RE: [EXTERNAL] Meeting on Comp Plan

RE: Public Hearing Canyon Park Sub-Area Plan Preferred Alternative

RE: Supplemental Public Hearing regarding Canyon Park Subarea Plan

SUBJECT: Canyon Park Subarea, Planned Action Draft EIS, December 2019
DEIS Addendum, July 2020
TENW Project No. 3696

Regulations, Figure 12.48.200

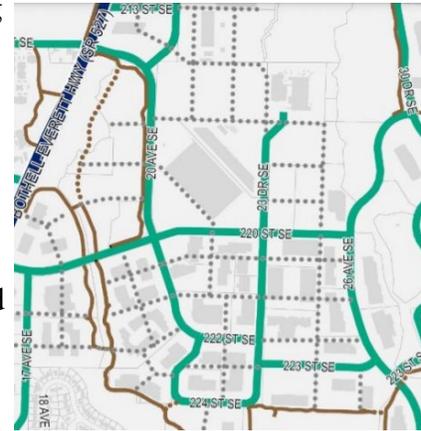
through-block connections required under the Regulations render the vast majority of developed CPBC lots significantly nonconforming. This is shown in Figure 12.48.200 of the Regulations, *see above*. Completion of these through-block connections requires complete redevelopment, including removal of many existing buildings throughout the Park. Given the relative age and condition of most buildings in the Park, redevelopment of such grand scale cannot reasonably be expected in the timeframe anticipated by the Subarea Plan.
